SINGAPOREAN NOTICES TO MARINERS

GSP1/SP1 9Ed 15/04/14 Last NM 95/2014 (Maritime and Port Authority of Singapore) **NM 96/2014**

Block for Chart SP1

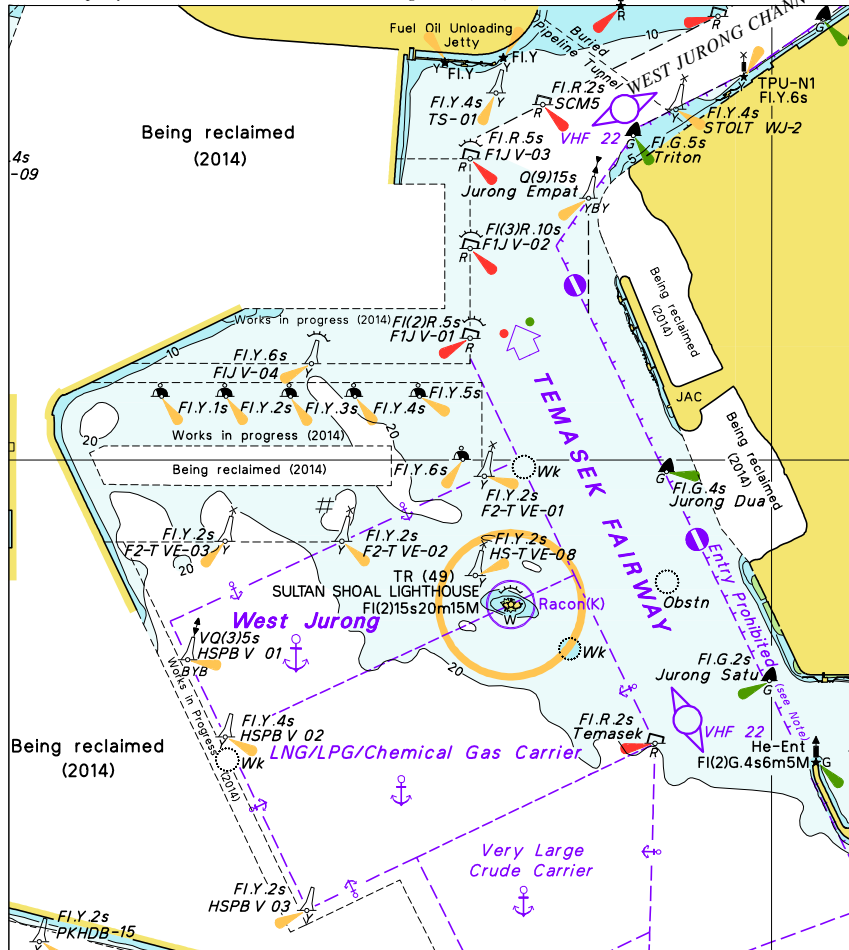
Insert the accompanying block, showing new reclamation limit,
revised Channel and Fairway limits, centred on: 1°16'26"N 103°38'86"E
